ENGINEERING REPORT

ISSUE NO.: **ER-26-0157-01**

MODEL: L1268	TITLE: Gap abnormal between Top_Cover and Right_Cover	APPROVED BY:  MURAKAMI ATSUSHI
PART NO.: RC7-0183-000	PURPOSE: Record and sharing	CHECKED BY: Le Thi Dung
PART NAME: Right_Cover		ISSUED BY: Ha Hoc Tu
		DATE: 2026-05-28 EXT: 8453

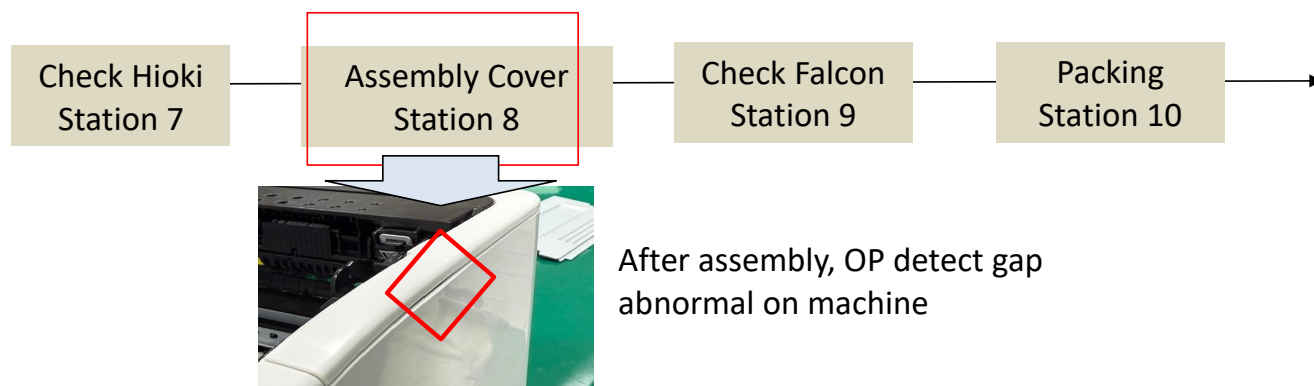
Cause: Interfere with Left cover and Cover_Gear because Part RC7-0183 have shape not good.

Check 3D VPS newest
PE1 rework part 87/87 (finished)

Interfere position

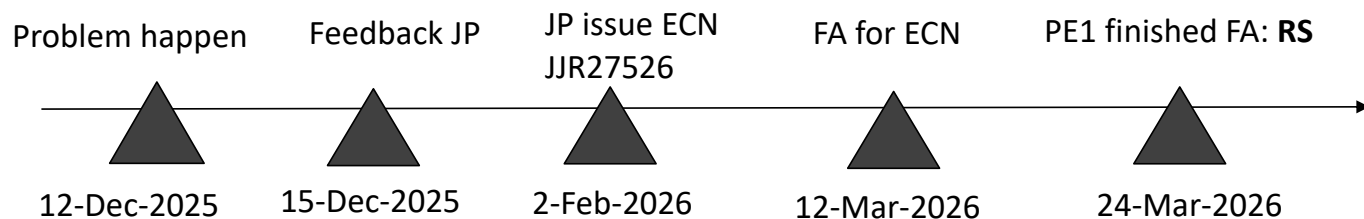
Check assembly situation: NG - Part have interfere

Assembly again
replace by FA part : Still NG

Check VPS 3D:Realize interfere between Right_Cover and Gear_Cover
➔ Conclusion Part shape not good.

- Feedback to JP
